SERVICE BULLETIN M20-311

Date: October 7, 2010

SUBJECT: Mooney M20TN - Exhaust Gas Temperature Probe Mounting
MODELS/ SN Mooney M20TN Acclaim and Type-S Aircraft (Serial Numbers 31-0004 thru 31-0128)
AFFECTED:

Figure SB M20-311-1 - EXHAUST GAS TEMPERATURE PROBE LOCATION

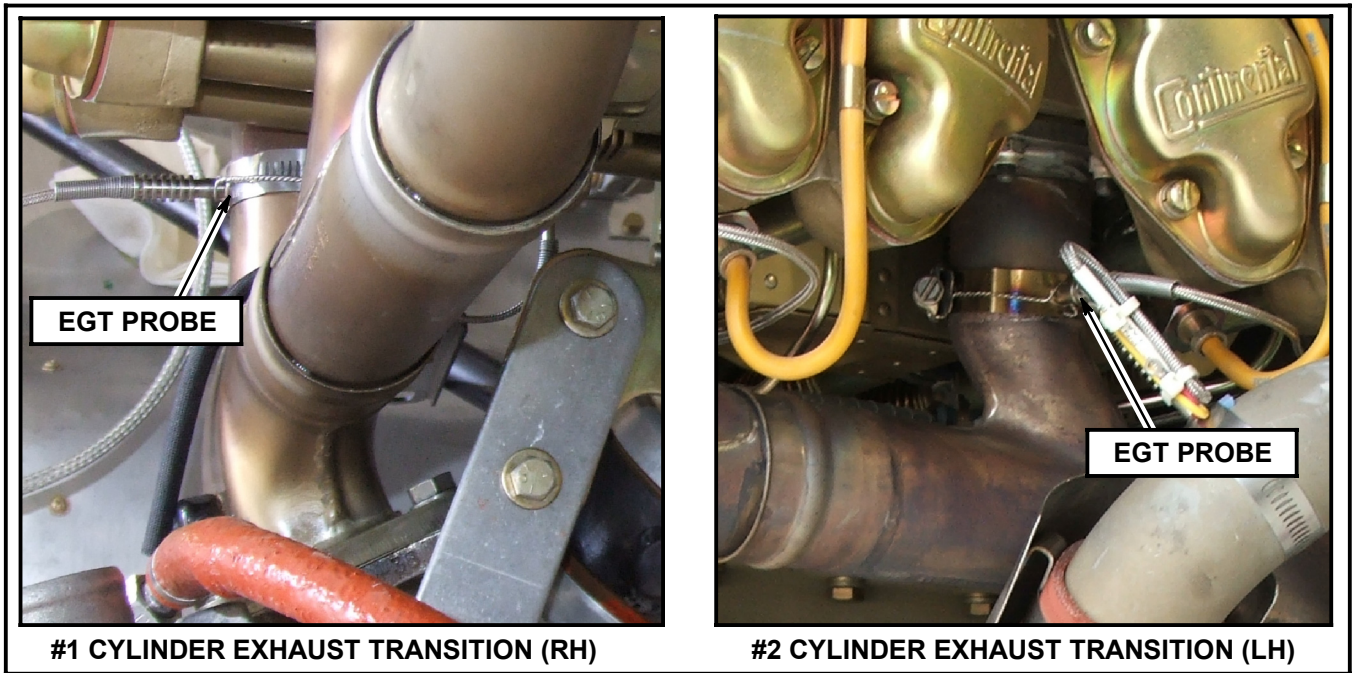
INTRODUCTION: There have been reports in the field of the EGT Probe mounting hole (#30 drill - .128") in Cylinders #1 and #2) were drilled oversized (.250") on M20TN Mooney Airplanes listed above. This will require an inspection and corrective action taken. **The attached compliance card needs to be filled out and returned to Mooney Airplane Company upon completion of this Service Bulletin M20-311.**

- 1.3 Locate #1 (RH) EGT probe, remove safety wire retaining probe from clamp.
- 1.4 Loosen and remove clamp and #1 RH EGT probe, take care not to damage probe.

- 1.5 Install new sealing washer p/n (900006-1) between EGT probe and exhaust tube.
- 1.6 Re-install clamp around #1 RH exhaust pipe ensuring correct orientation of clamp tightening screw. Place probe tip into hole and tighten clamp to remove looseness.

- 1.7 Torque clamp to 30-35 in.lbs. and secure with safety wire to prevent loosening.
- 1.8 Locate #2 (LH) EGT probe, remove safety wire retaining probe from clamp.

- 1.9 Loosen and remove clamp and #2 LH EGT probe, take care not to damage probe.
- 1.10 Install new sealing washer p/n (900006-1) between EGT probe and exhaust tube.

- 1.11 Re-install clamp around #2 LH exhaust pipe ensuring correct orientation of clamp tightening screw. Place probe tip into hole and tighten clamp to remove looseness.
